Piper Aircraft Corporation  
2926 Piper Drive  
Vero Beach, Florida, U.S.A. 32960

# SERVICE No. 979 BULLETIN

DATE: January 12, 1995

INSTALLATION OF FUEL CAP COVER

SKETCH A

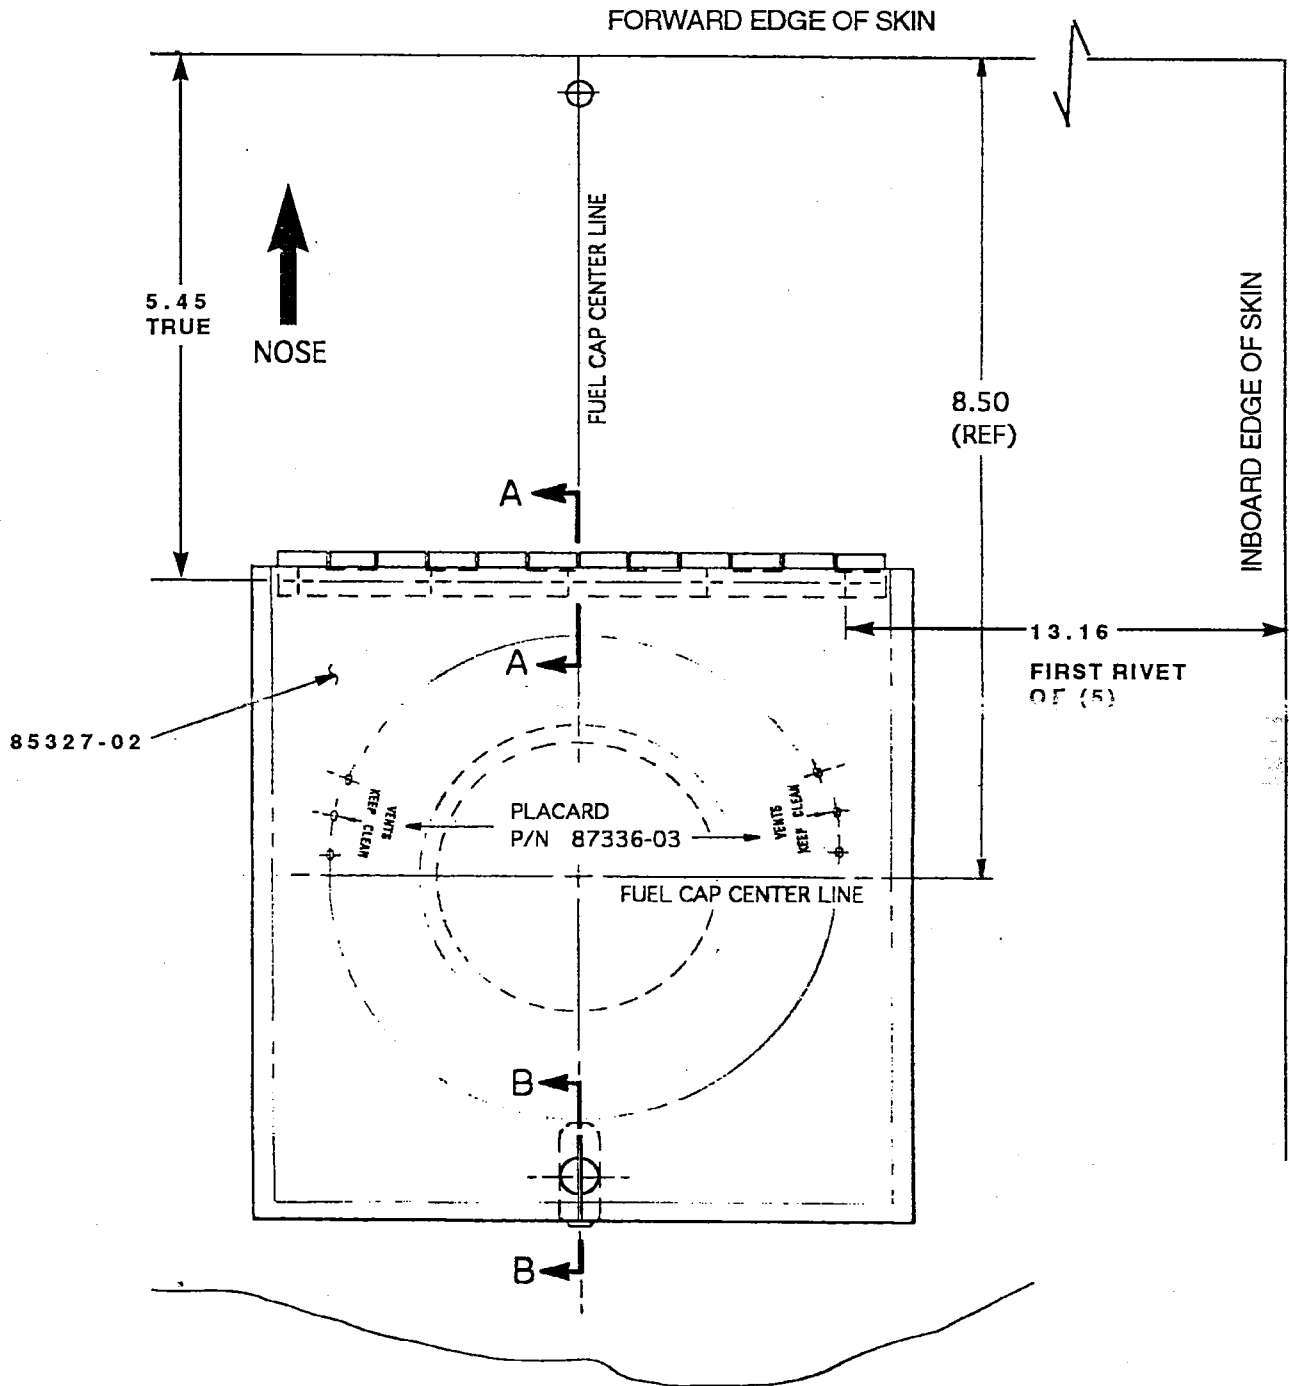
1. Remove the right and left fuel tank cover skins located on the top of each wing.
2. Using the Cover Assembly, Piper Part Number 85327-02, lay out the fuel cap cover assembly hinge location on the fuel tank cover skins by marking through hinge holes per Sketch A.
3. After the locations are marked, drill five .0937 holes for the hinge and deburr.
4. Paint fuel cap covers to match aircraft. The color information is given on the first page of the airframe log book or in the parts catalog aerofiche. Allow paint time to dry before continuing.
5. Rivet fuel cap covers to the tank cover skins with five MS20470AD3 rivets of proper length.

13. Install two Placards, Piper Part Number 87336-03, next to the vent holes as shown on Sketch A on each of the new cover assemblies.
14. Remove fuel caps. Remove existing gasket from each fuel cap and discard. Install one new Gasket, Piper Part Number 66815-02 on each fuel cap. Replace and secure fuel caps and new fuel cap covers.

SKETCH B

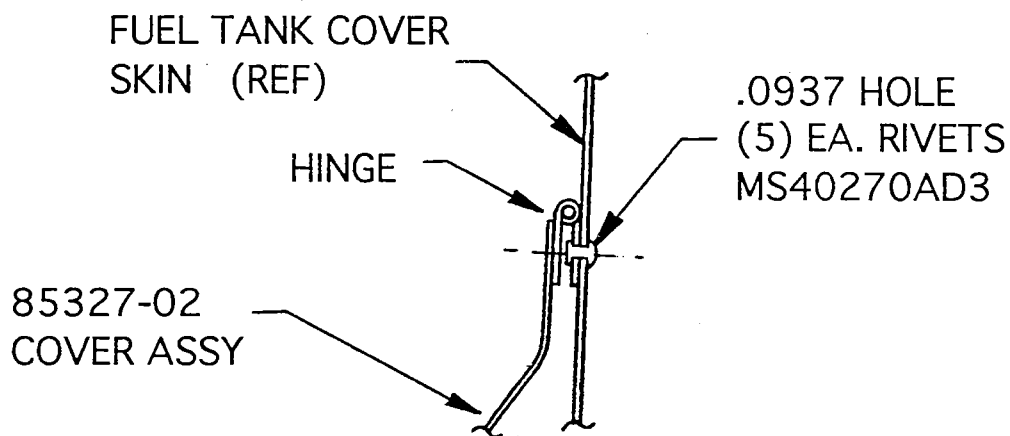
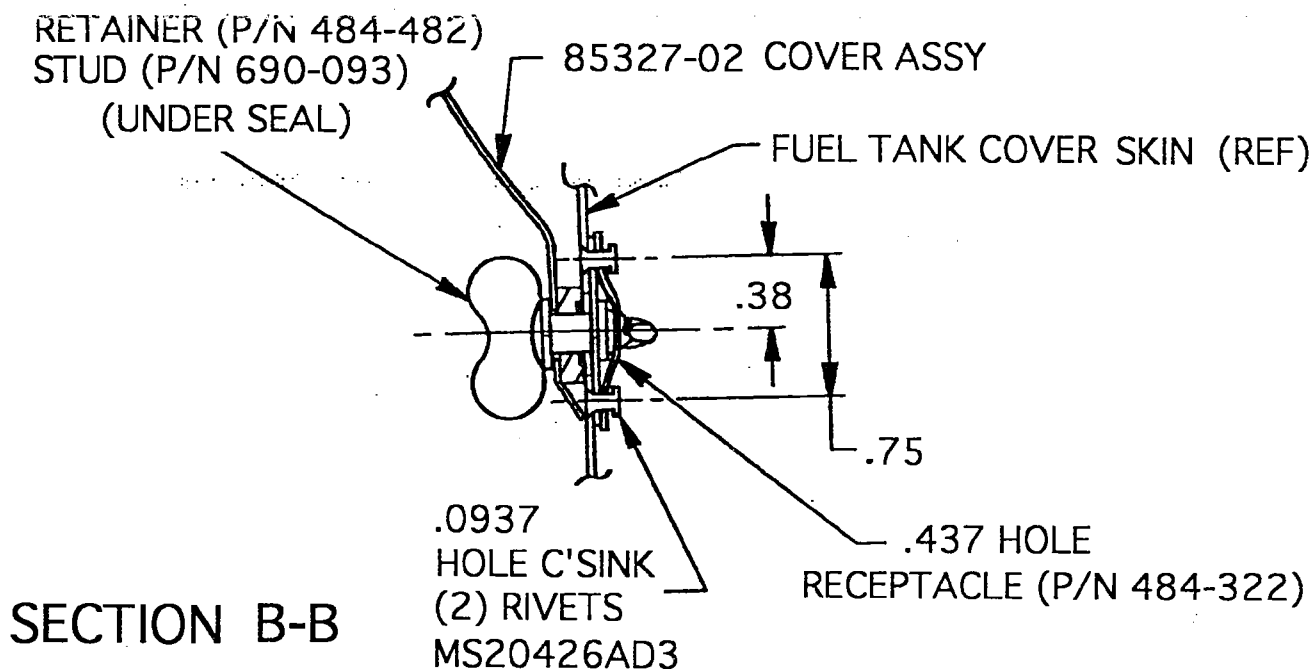
6. Place fuel cap cover in closed position and mark the location for the retainer hole. Open cover and drill a .437 hole for the retainer per Section B-B of Sketch B.

7. Place the Retainer, Piper Part Number 484-482, through the fuel cap cover assembly and tank cover skins.
8. Attach the receptacle to the retainer on the bottom side of the tank cover skin and latch into place per Section B-B of Sketch B.

11. Countersink and deburr the holes. Rivet the receptacle into place with two MS20426AD3 rivets of proper length as shown on Section B-B of Sketch B.
12. Reinstall tank cover skins on the aircraft. Open and close new fuel cap covers and check for proper fit and operation.
